HITACHI SEMICONDUCTOR TECHNICAL UPDATE

Classification of Production	MCU		No	TN-SH7-420A/E	Rev	1
THEME	On SH7065 usage notices of MMT	Classification of Information	1. Spec change 2. Supplement of Documents ③ Limitation of Use 4. Change of Mask 5. Change of Production Line			
PRODUCT NAME	HD64F7065AF60 HD6437065AF60 HD64E7060S	Lot No.	Reference Documents	SH7065 Hardware manual Rev.4.0 (ADE-602-166C)	Effective Date	
		ALL			Permanent

1. Additional notices onto 「usage notice」

Below figures show the error case.

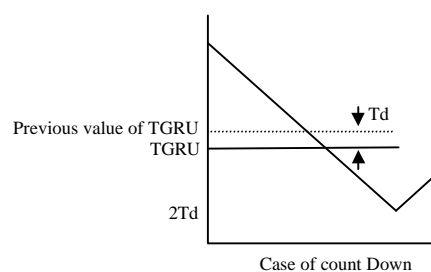
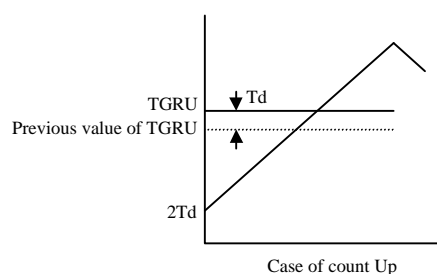
(3) Pay attention to the notices below, when a value is written into the Timer General Register U (TGRU), Timer General Register V (TGRV), Timer General Register W (TGRW), and in case of written into free operation address (*).

- Incase of Count UP: Do not write a value 「Previous value of TGRU + Td」 into TGRU.
- Incase of Count DOWN: Do not write a value 「Previous value of TGRU - Td」 into TGRU.

In the same manner to TGRV, and TGRW.

When a value 「Previous value of TGRU + Td」 is written (in case of Count DOWN「Previous value of TGRU - Td」), the output of PUOA/PUOB, PVOA/PVOB, PWOA/PWOB (corresponding to U, V, W phase) may not be output for 1 cycle.
